SERVICE BULLETIN

POWER PLANT - ENGINE - PROVIDE A P2/T2 LINE BRACKET WITH LOCKWIRE HOLES - CATEGORY
CODE 4 - MOD.ENG-71-0108

V2500-ENG-71-0108

Modification of the P2/T2 Air Tube Bracket - Before and After Alteration
Fig.2

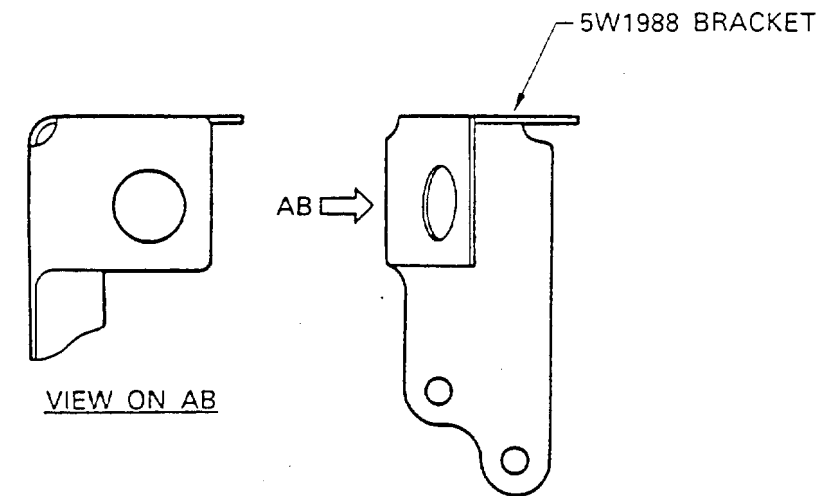
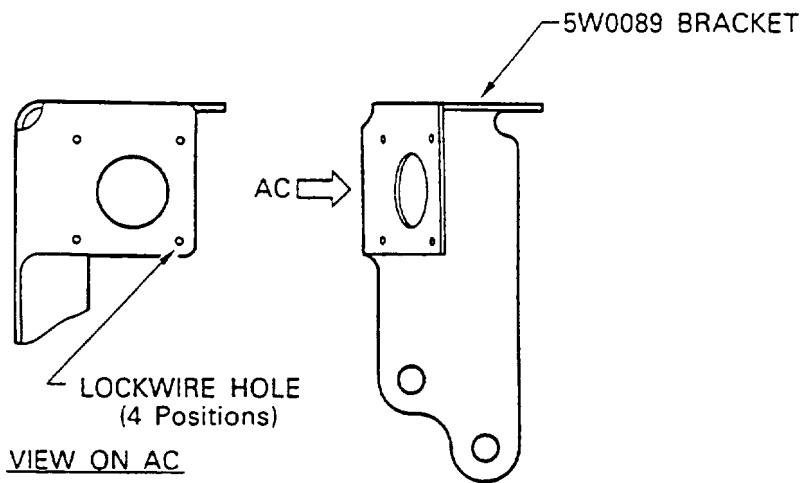
- (1) The changes introduced by this Service Bulletin are as follows:
- (a) A new Bracket 5W0089 which has the four lockwire holes is introduced to wire-lock the Nut on Flexible Hose and the locking Nut of P2/T2 Air Tube through the lockwire holes, see Fig.2.
- (2) The existing Bracket can be reworked to a new configuration, see Fig.3.
- (3) Revised wire locking for the Nut on Flexible Hose and Locking Nut of P2/T2 Air Tube, see Fig.4.

VIEW AT AA BEFORE ALTERATION

VIEW AT AA AFTER ALTERATION

- (1) Attach the new 5W0089, Bracket, with two 4W0103, Bolts, to the Relay Box Mount Bracket, refer to Fig.2.
- (2) Torque each of two 4W0103, Bolts, to 36 - 45 lbfin (4,00 - 5,00 Nm).
- (3) Install MS9201-06, Locking Nut, to 5A8738, P2/T2 Air Tube, and the new 5W0089, Bracket. Tighten MS9201-06, Locking Nut, with a torque of 70 - 80 lbfin (7,9 - 9,0 Nm).
- (4) Connect the Nut on 5A0148, Flexible Hose, to 5A8738, P2/T2 Air Tube. Tighten the Nut on 5A0148, Flexible Hose, to a torque of 182 - 199 lbfin (20,5 - 22,5 Nm).
- (5) Safety the Nut on 5A0148, Flexible Hose, and MS9201-06, Locking Nut, with CoMat 02-126, Lockwires, independently to the new 5W0089, Bracket, refer to Fig.4 and 1.K.(3).

Modification of the P2/T2 Air Tube Bracket
Fig.3

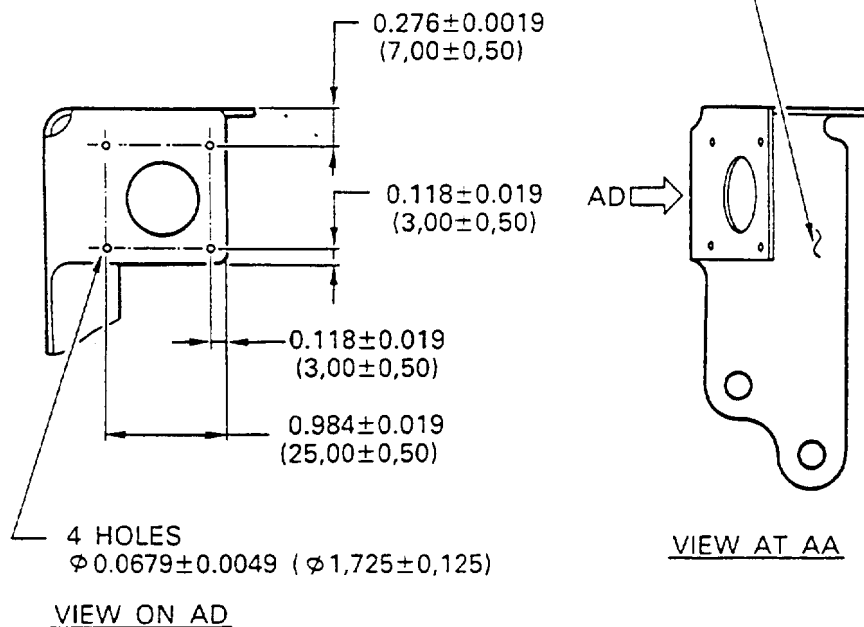
MARK NEW PN 5W0089 WITH VIBRO-PEEN
ADJACENT TO OLD PN 5W1988 IDENTIFIED
HERE. MARK TWO LINES (==) ON THE
OLD P / N WITH VIBRO-PEEN TO ERASE IT.

REWORK OF P2 / T2 AIR TUBE BRACKET

Procedure	Supplementary Information				
(1) Mark position of the four holes and center punch the hole centers	Refer to Fig.3				
(2) Drill the four lockwire holes in 5W1988, Bracket	Refer to Fig.3. Clamp the Bracket in the vice on a pillar drill and use 0.063in. (1,6 mm.) drill				
(3) Remove all the burrs from around the drilled holes					
(4) Visually examine the drilled holes for cracks	No cracks are permitted				
(5) Renumber by the Vibro-Peen adjacent to the existing Part Number	Refer to Fig.3 <table><tr><td>Existing</td><td>Renumber</td></tr><tr><td>5W1988</td><td>5W0089</td></tr></table>	Existing	Renumber	5W1988	5W0089
Existing	Renumber				
5W1988	5W0089

Modification of the P2/T2 Air Tube Bracket
Fig.4

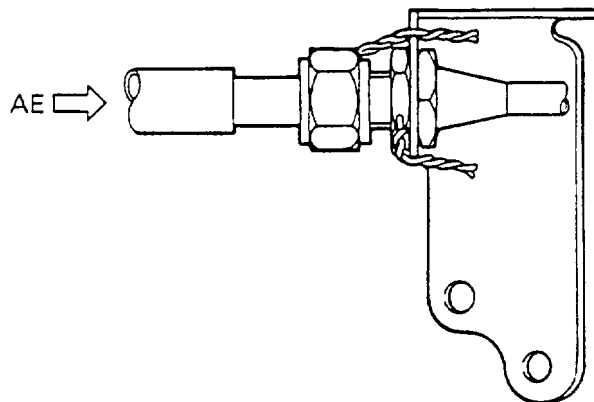
REPEAT VIEW AT AA
SHOWING CONNECTIONS LOCKED
FOR SAFETY WITH LOCKWIRE
AFTER MODIFICATION
